ADDENDUM #1

Issue Date: 3/17/2025
Project Name: American Family Field – Restroom Alteration
Project Address: 1 Brewers Way
Milwaukee, WI 53214

Zimmerman Project Number: 250012.01

AMERICAN FAMILY FIELD - Restroom Alteration - Corporate Office Lobby (Field Level)

1 FIELD LEVEL - DEMOLITION WORK
SCALE: 1/4" = 1'-0"

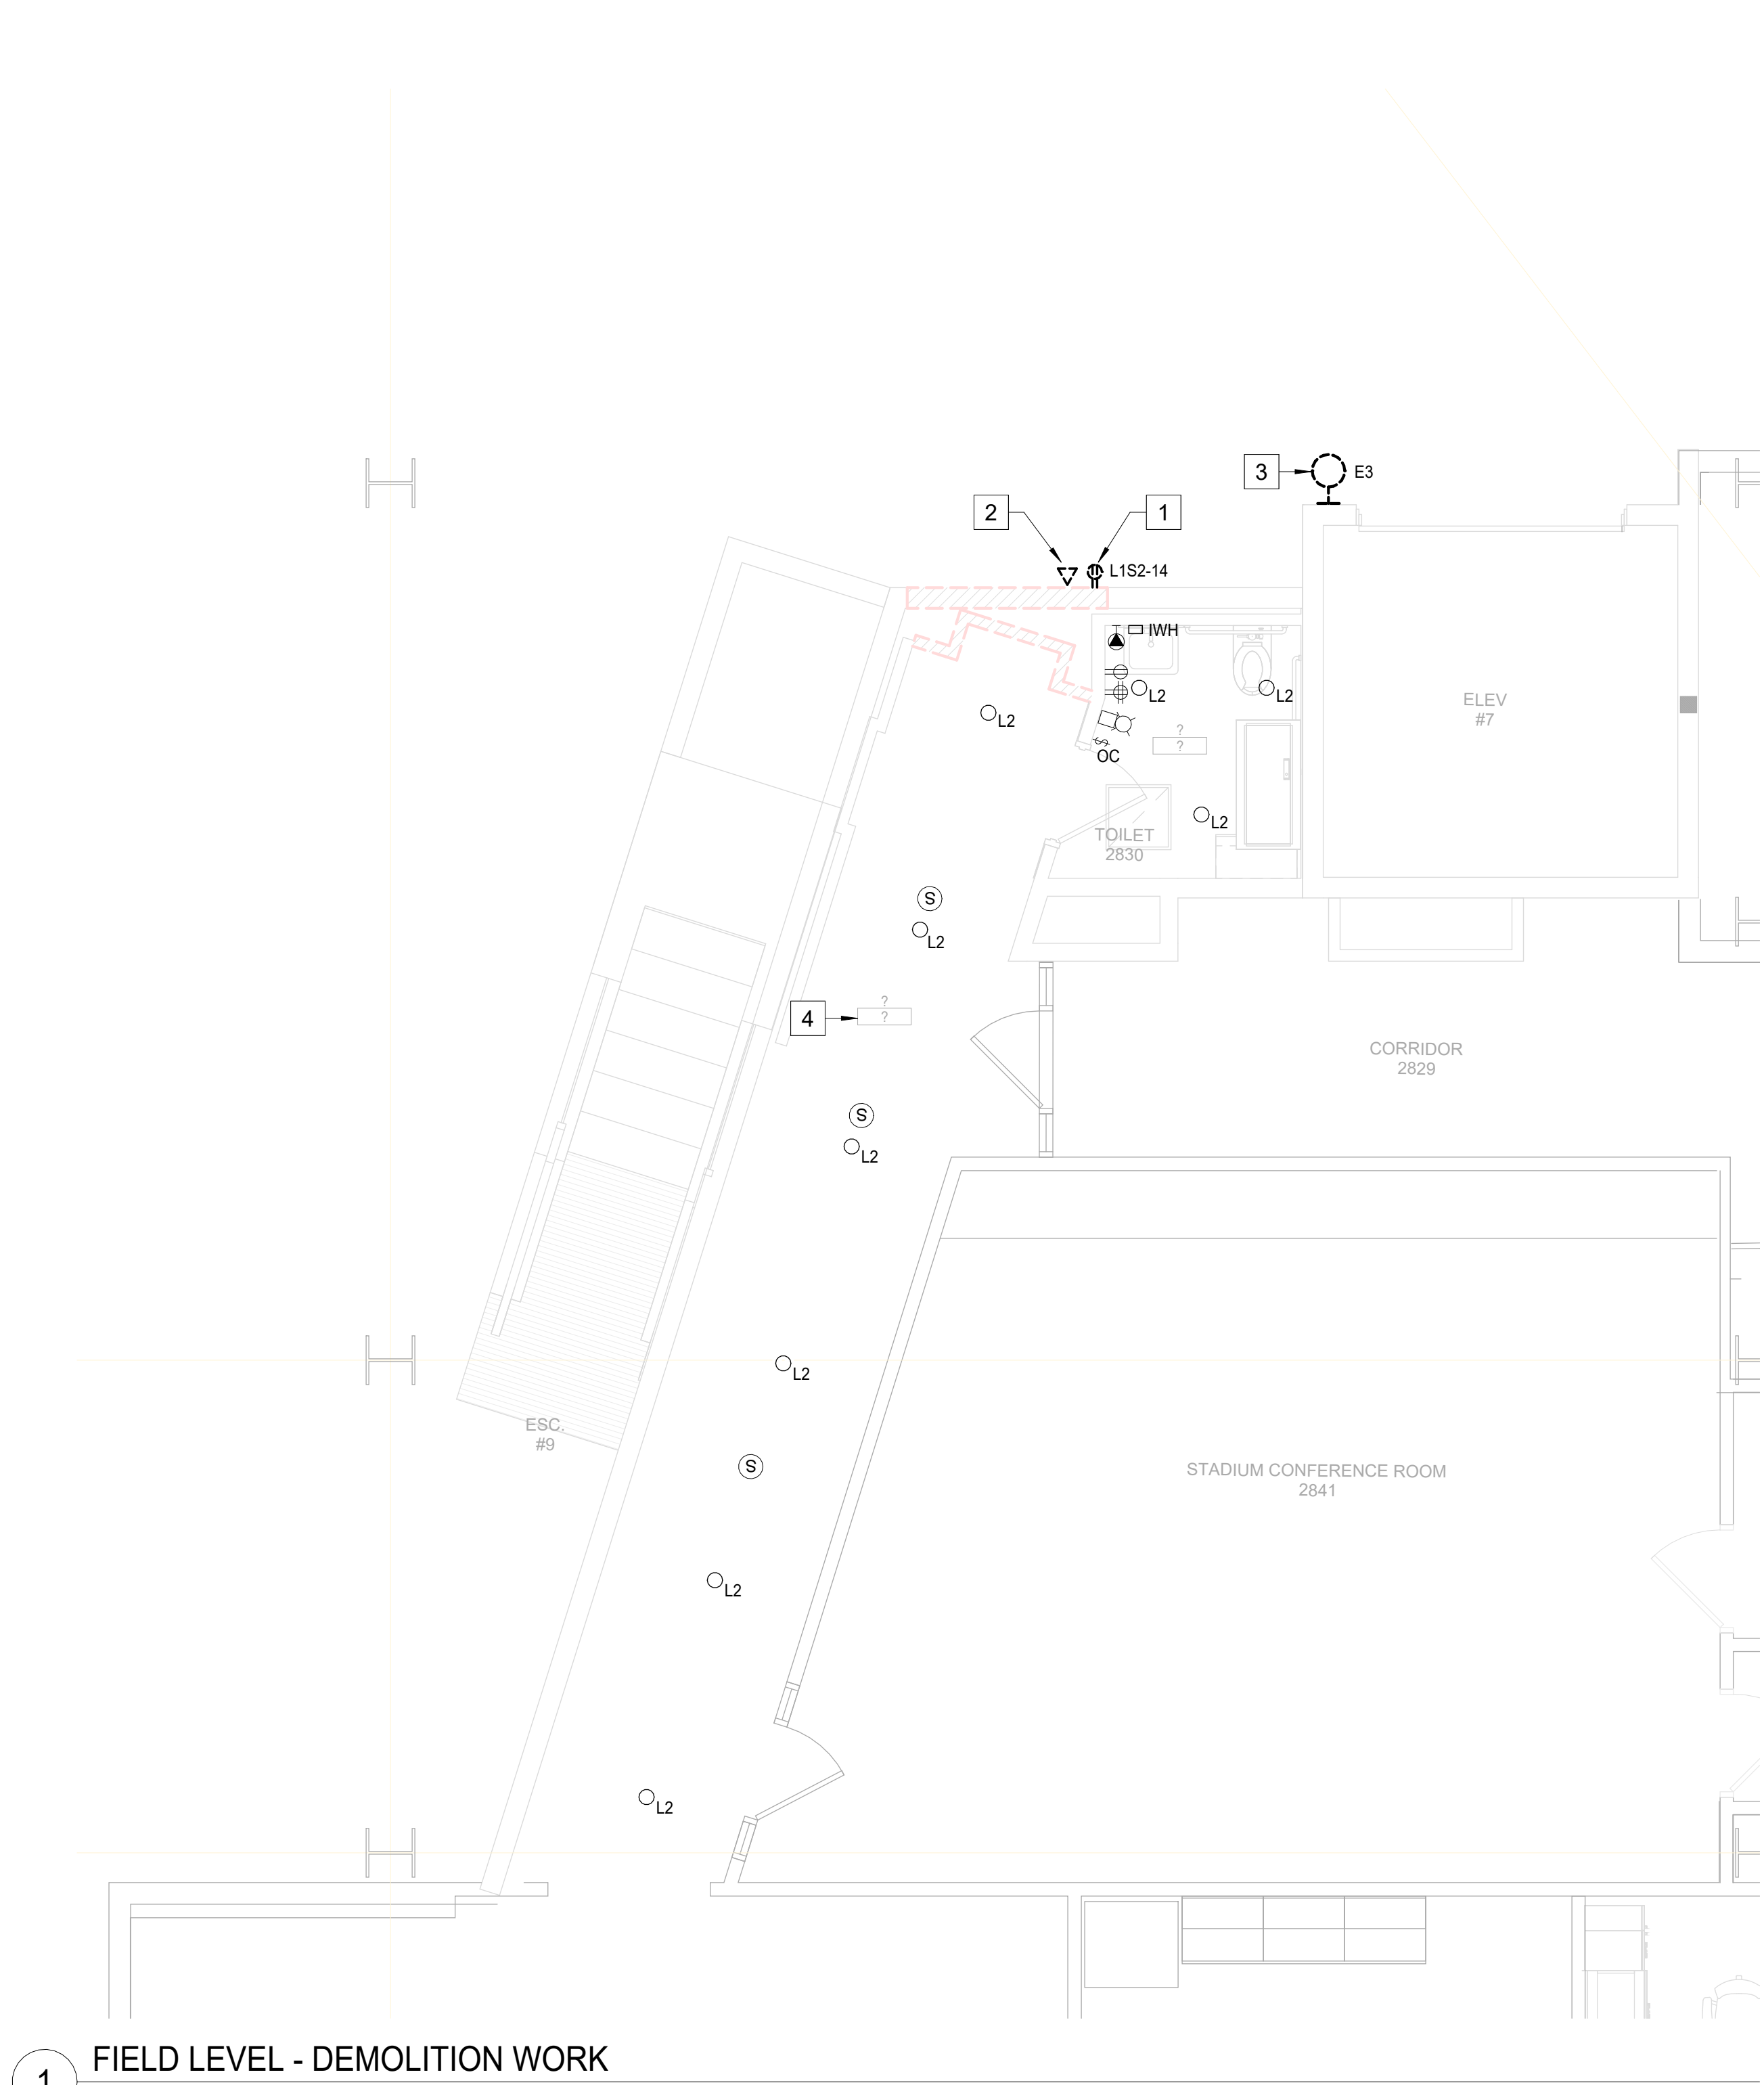
- Remove: New scope OF WORK from sheet, move new scope of work to new sheet E102.

1 FIELD LEVEL - NEW WORK
SCALE: 1/4" = 1'-0"

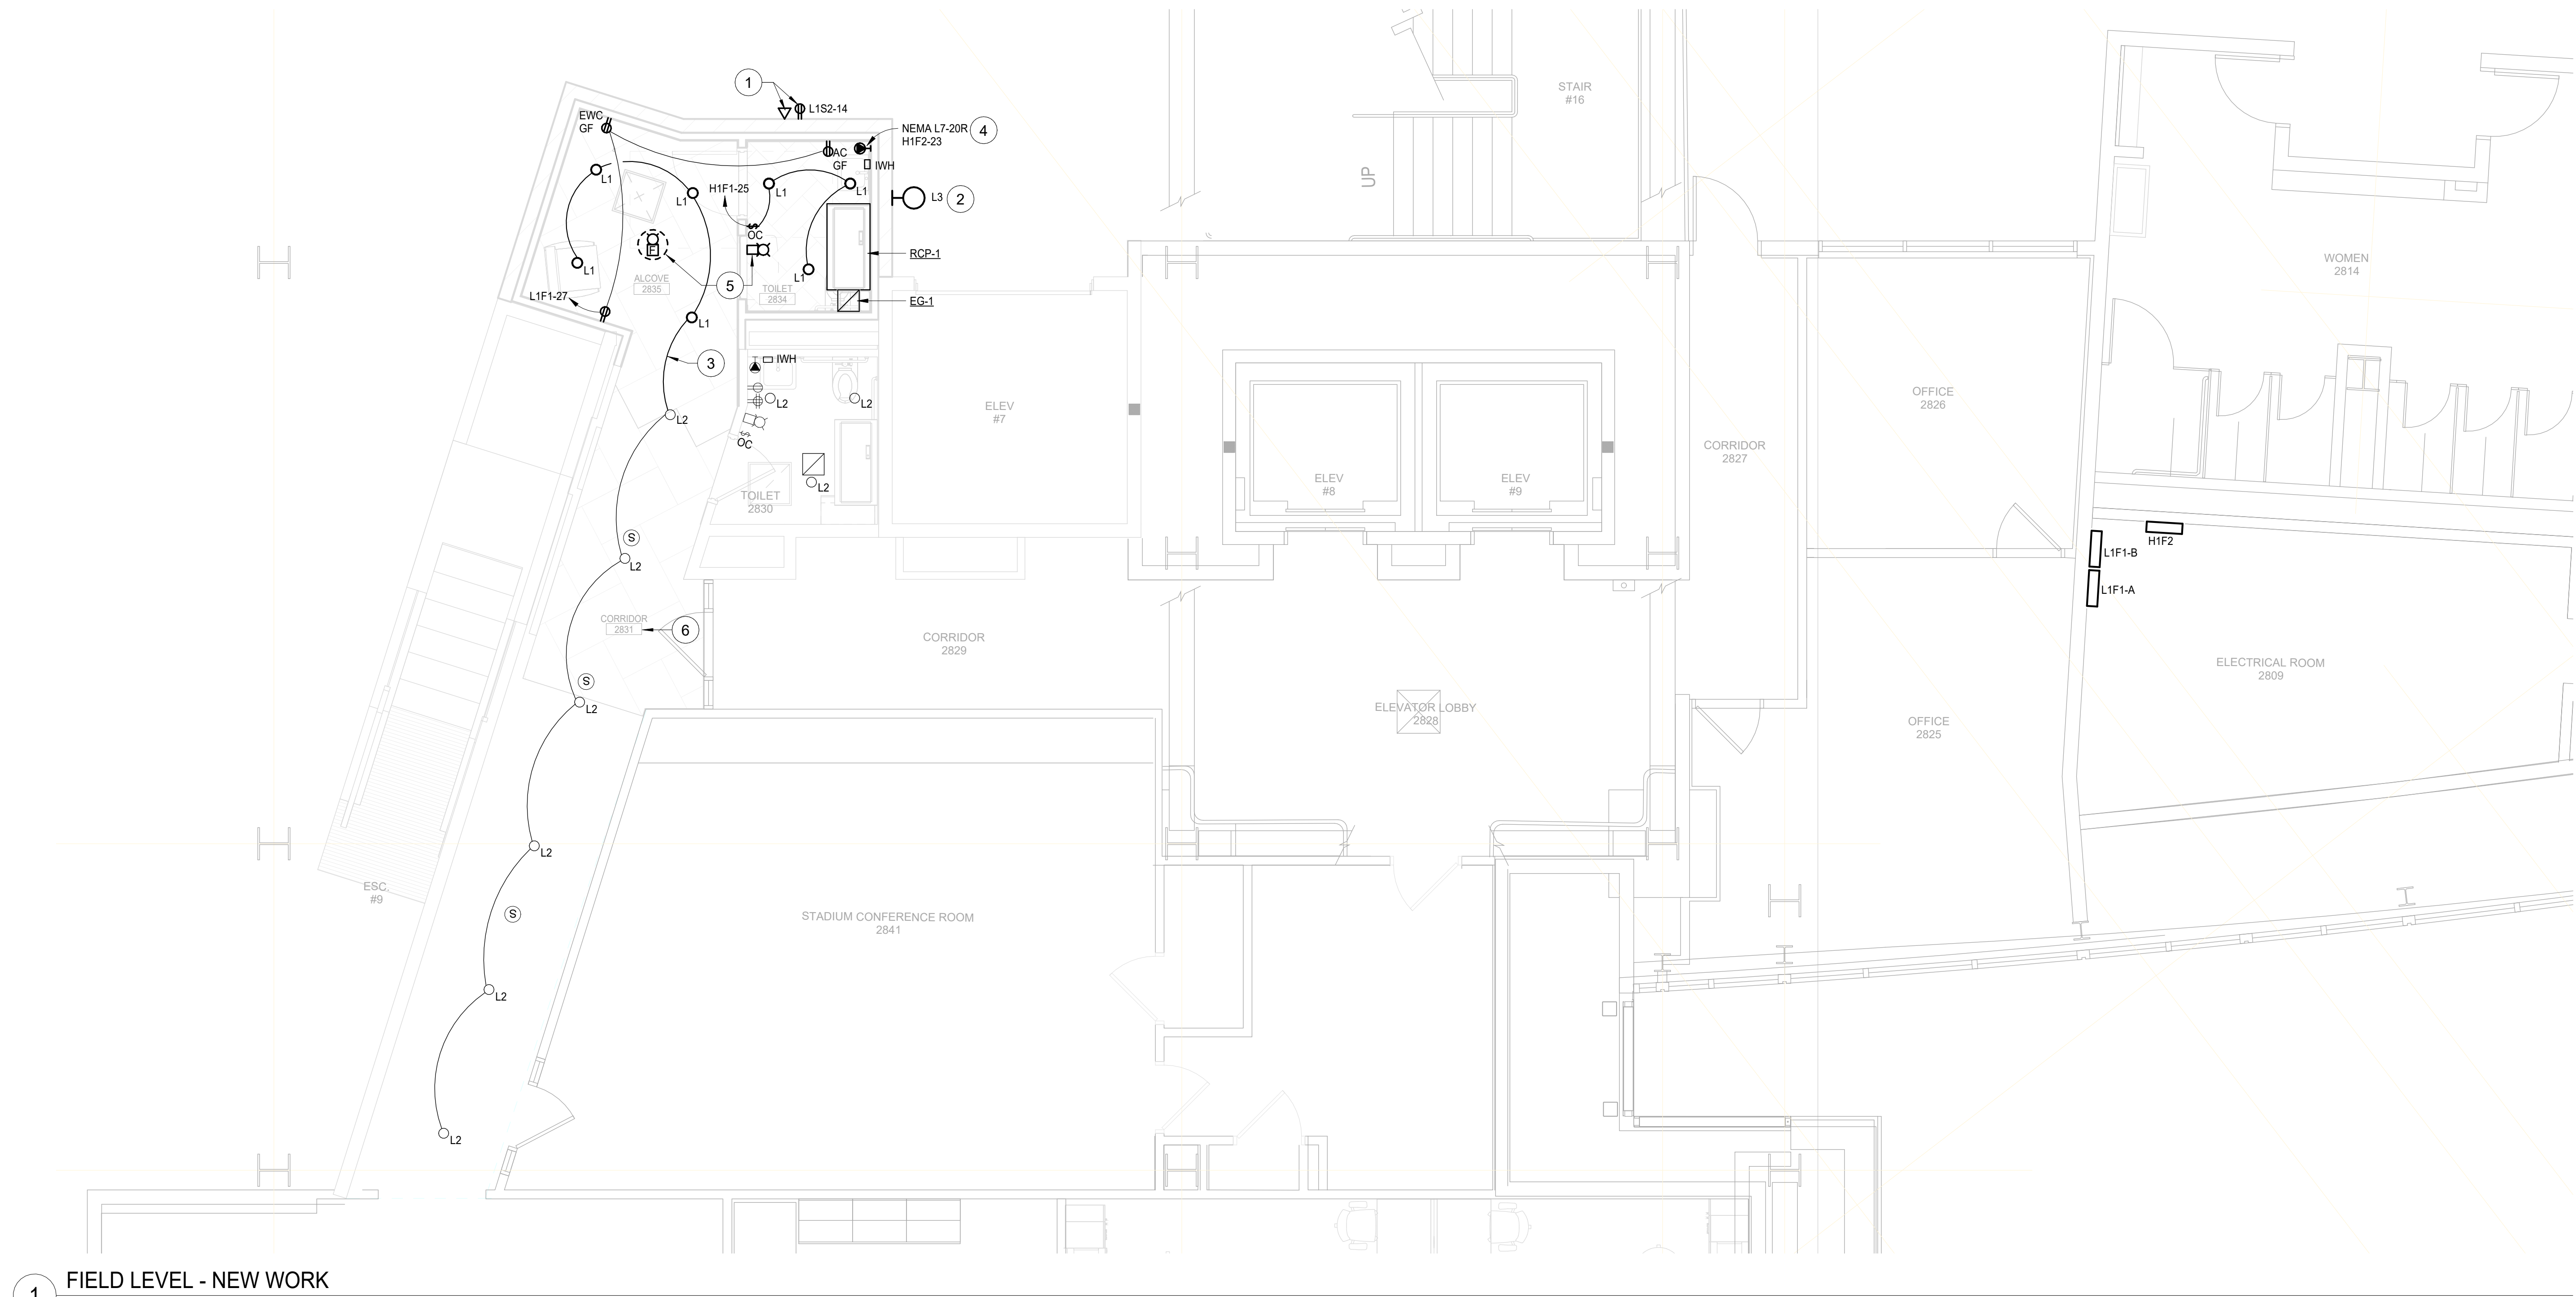
- ADD: This new sheet to separate out all new work.
- MODIFY: Viewport to include location of electrical room for takeoffs.
- ADD: general note to include Fire Alarm contractor contact information.

1. SURROUNDING AREA WILL BE OCCUPIED. MAINTAIN POWER TO EXISTING POWER SYSTEMS, LIGHTING FIXTURES, LIGHTING CONTROLS, DATA SYSTEMS ETC. OUTSIDE THE SCOPE OF WORK TO MINIMIZE DISRUPTION TO BUILDING OCCUPANTS.
2. SEE SHEET E200 FOR LIGHTING FIXTURE SCHEDULE AND PANEL SCHEDULES.
3. PANEL L1F1 AND H1F2 ARE LOCATED IN NEARBY ELECTRICAL ROOM 2809.
4. SEE SHEET E002 FOR MINIMUM BRANCH CIRCUIT SIZING REQUIREMENTS AND E200 FOR ADDITIONAL CIRCUITING REQUIREMENTS.
5. GUETZKE INC. IS THE FIRE ALARM CONTRACTOR. CONTACT MARCUS MEINZER AT 262-844-4386 OR MARCUS.MEINZER@GUETZKEINC.COM.
